## SYDNEY NORTH PLANNING PANEL

<b>SNPP No</b>	2016SYE063
<b>DA Number</b>	LDA2016/258
<b>Local Government Area</b>	City of Ryde
<b>Proposed Development</b>	Mixed use development containing 102 apartments, two commercial tenancies and car parking for 133 vehicles, and landscaping works
<b>Street Address</b>	400-426 Victoria Road, Gladesville
<b>Applicant</b>	Fox Johnston Architects
<b>Number of Submissions</b>	During the final notification period 2 submissions were received - 1 supporting the application and 1 objecting to the development
<b>Regional Development Criteria (Schedule 4A of the Act)</b>	General Development over \$20 Million
<b>List of All Relevant S79C(1)(a) Matters</b>	<ul style="list-style-type: none"> <li>• State Environmental Planning Policy (State and Regional Development) 2011</li> <li>• State Environmental Planning Policy No. 55 (Remediation of Land)</li> <li>• State Environmental Planning Policy (Building Sustainability Index: BASIX)</li> <li>• State Environmental Planning Policy No. 65 – Design Quality of Residential Flat Development</li> <li>• State Environmental Planning Policy (Infrastructure) 2007</li> <li>• Deemed State Environmental Planning Policy Sydne

Figure 3. To improve the light and air to the sleeping areas in the studio apartments, high level glass louvers have been provided.

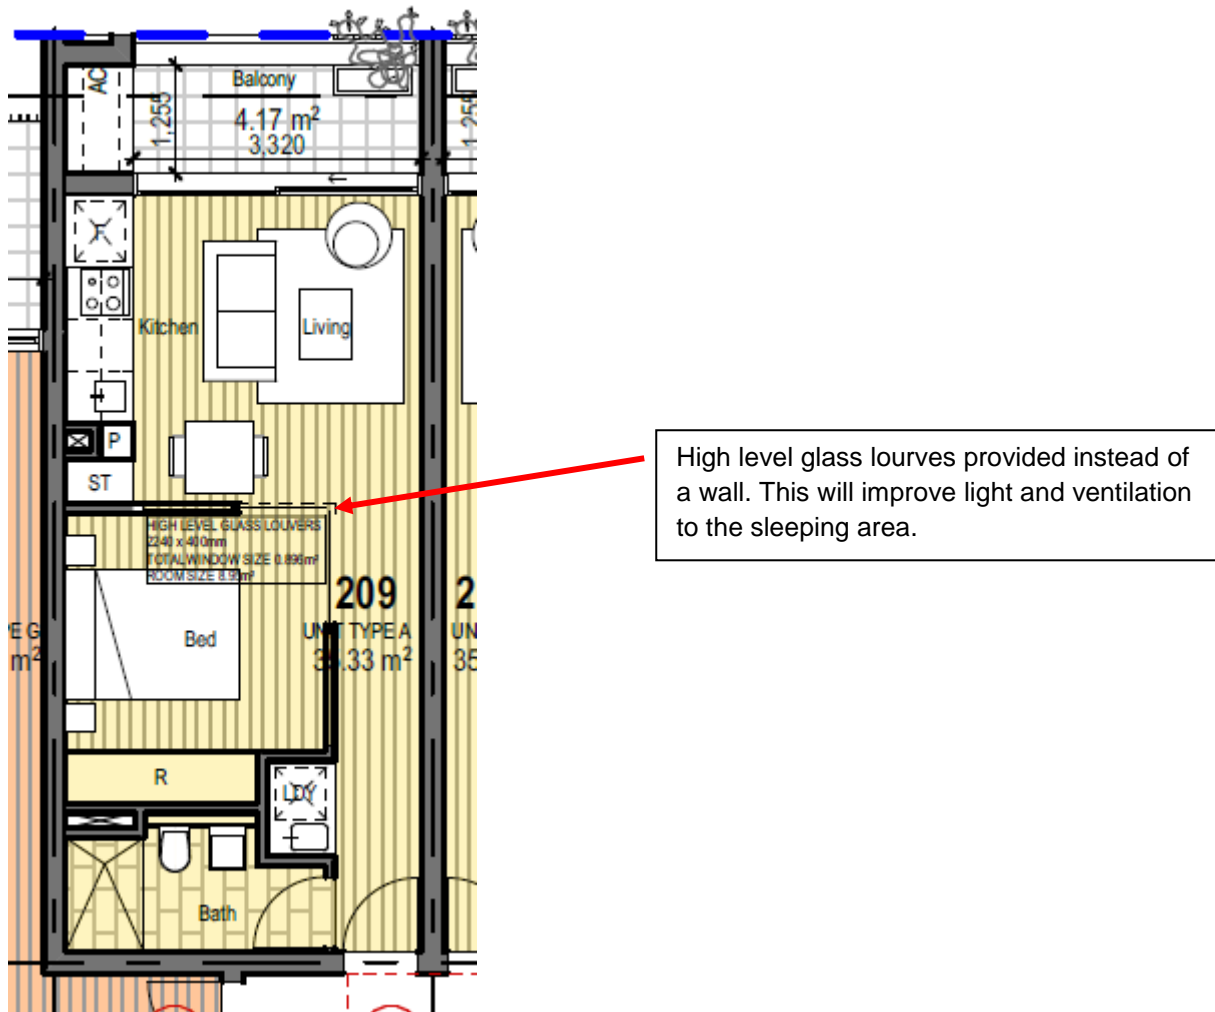
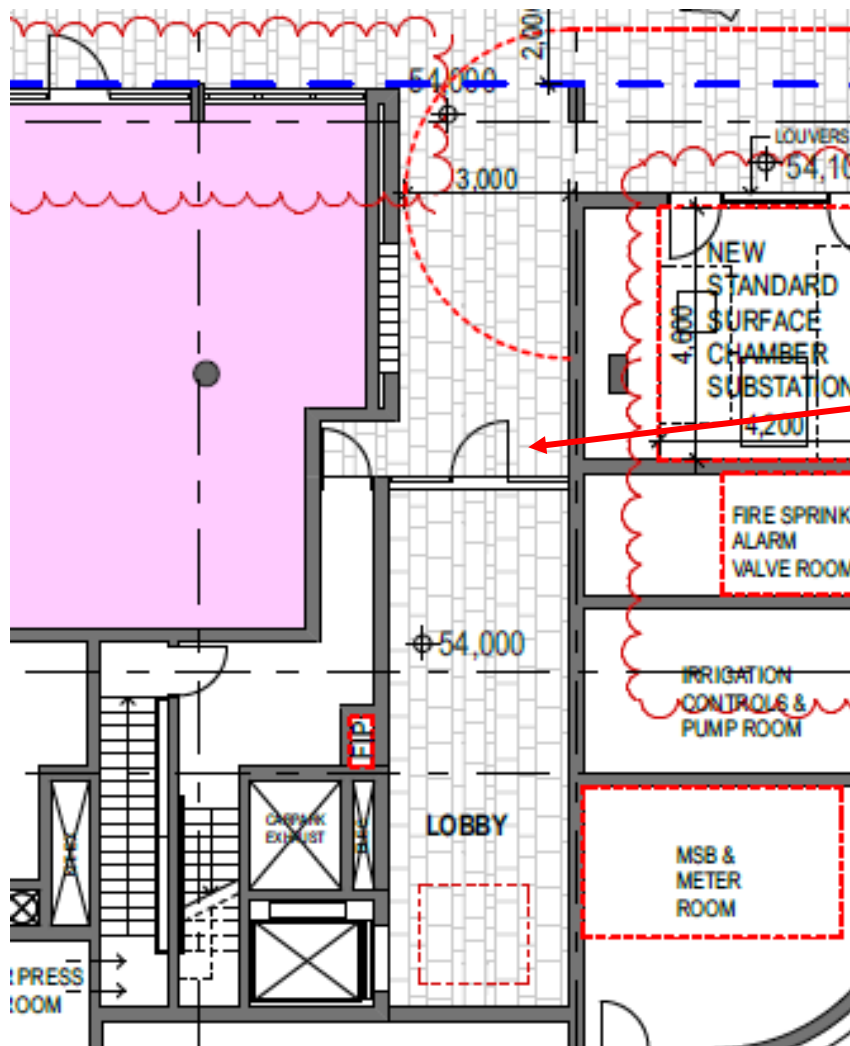
*The Panel is concerned about the internal amenity of studio apartments 106, 107, 108, 116, 117 and above. Balcony depths are too shallow and it is not clear how the deeper part of the balconies for units 106 to 108 can be furnished. It appears that the amount of light received by the habitable space behind the balconies is significantly restricted by the fixed blades and landscaping shown on the drawings. Of further concern is the sleeping area in each unit, which is too enclosed and may not receive sufficient light and air, particularly noting the extent of balcony overhead from the unit above.*

**Comment:** The Panel raised concerns about the internal amenity of various apartments. The apartments in question are all studio apartments with a minimum size of 35.33m<sup>2</sup>. These sizes meet the minimum internal areas as required by the ADG. To improve light and air to the sleeping area of these apartments, the applicant has amended the plans to delete part of a wall and replace the wall with high level glass louvers. This is demonstrated on Figure 3.

Figure 5. Victoria Road elevation. The amended plans have introduced a step in the building. This not only ensures compliance with the height control but it also reduces the scale and massing of the building.

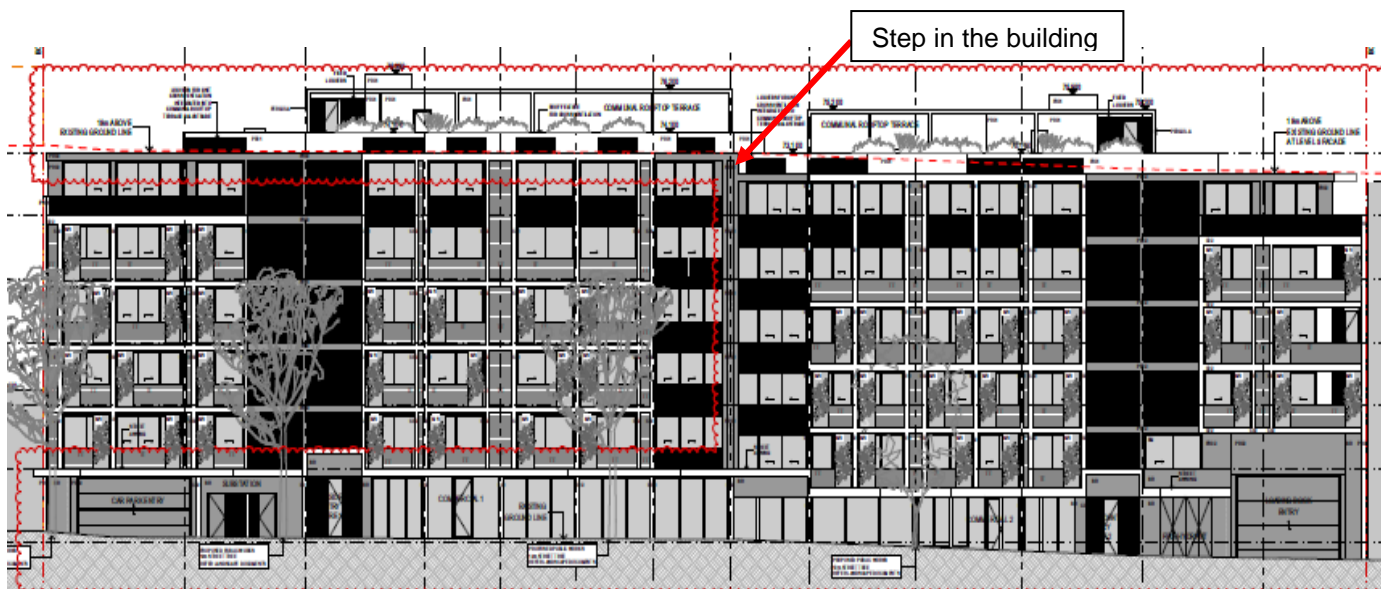
*The Panel believes that the Victoria Road elevation requires further development to reduce the perceived scale of the building and provide greater visual variety. Requirements related to road noise mitigation under SEPP Infrastructure may also influence the design outcome.*

**Comment:** The building height has been reduced by the introduction of a 1m step in the building. This has ensured that the public domain along Victoria Road as well as the aesthetics of the building have been improved. This step, combined with articulation has ensured that the scale and massing of the Victoria Road frontage is acceptable.

Figure 7. Section AA of the building demonstrating the breach to the 19m height control. Section AA is taken through the residential lobby on the eastern end of the building.

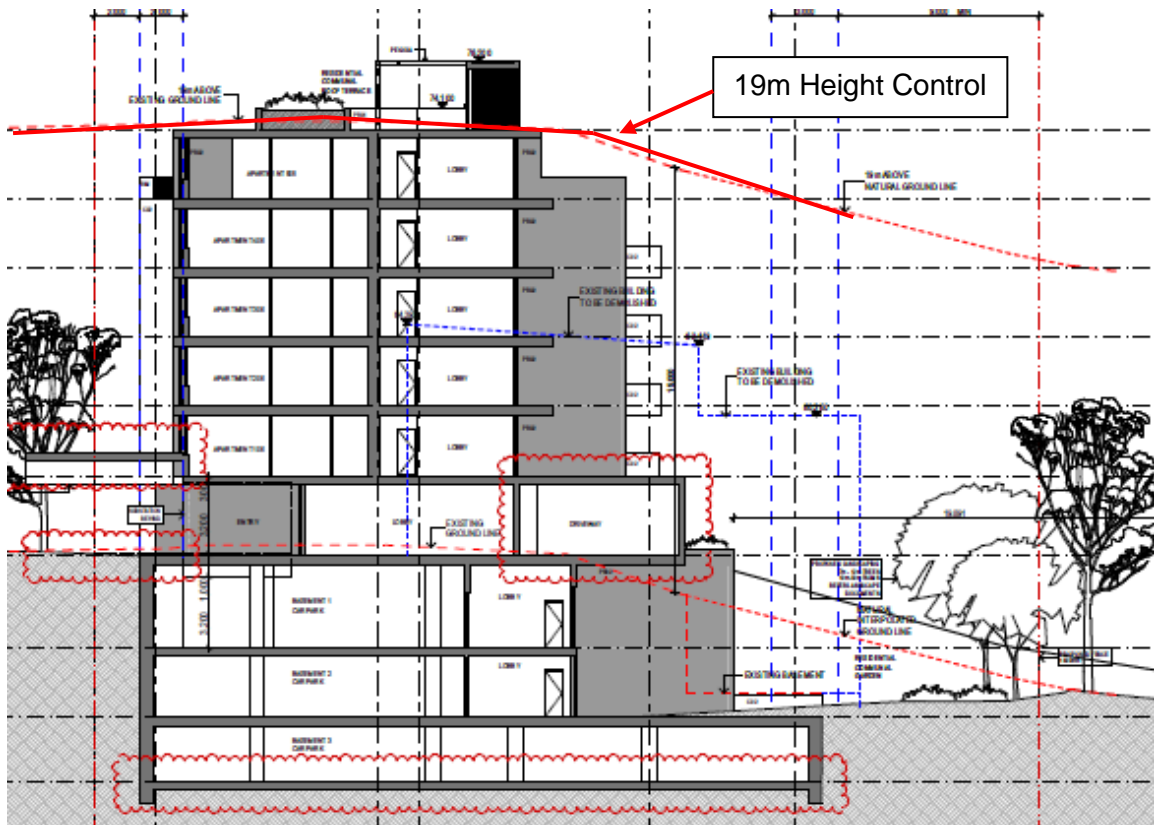
The development results in breaches to the 19m height control to accommodate the communal open space elements provided on the roof of the building. This includes planter beds, pergola, lift and stair access. Figures 6 and 7 demonstrate the typical sections through the building and illustrate the height control. The maximum breach which occurs for the lift, stair and plant rooms is equivalent to 3.88m above the 19m control. The maximum breach for the planter beds is equivalent to 0.4m above the 19m height control.

Figure 11. Area of the development that extends beyond Grid E.

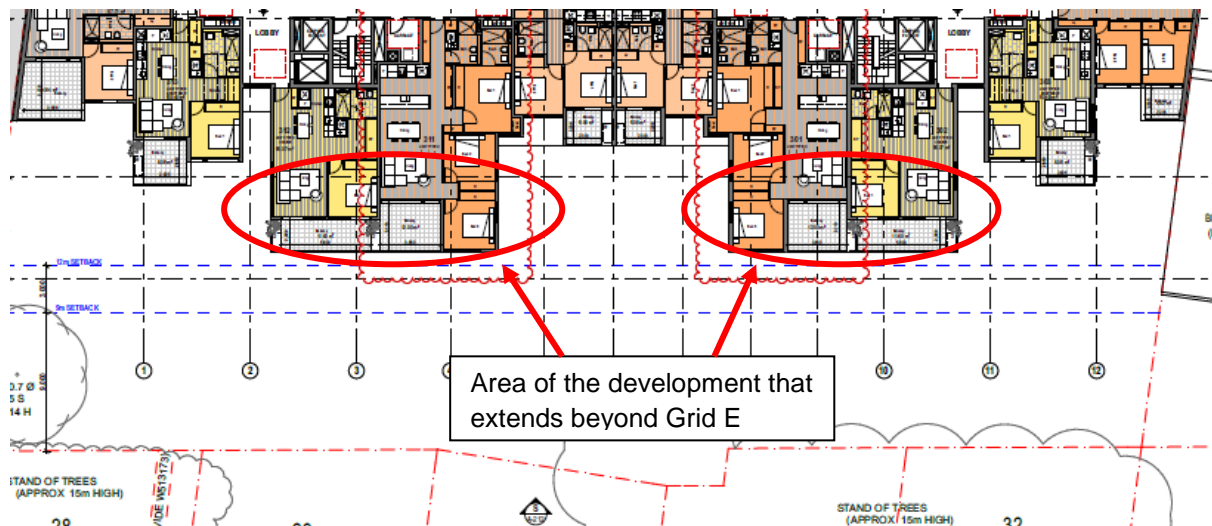
- That part of the building that extends beyond Grid E are excessive in height and should only be 12m in height. This would then comply with the DCP.

**Comment:** The following diagram demonstrates the area referred to in the submission.

The DCP requires a 9m ground level setback at the rear of the site. The development has complied with this control in respect to the two lower residential levels (basements 1 and 2). The upper residential levels beyond Grid E have been setback a minimum of 12.5m. That part of the building which is setback 12.5m is permitted to have a building height of 19m. This part of the building also complies with the height control.
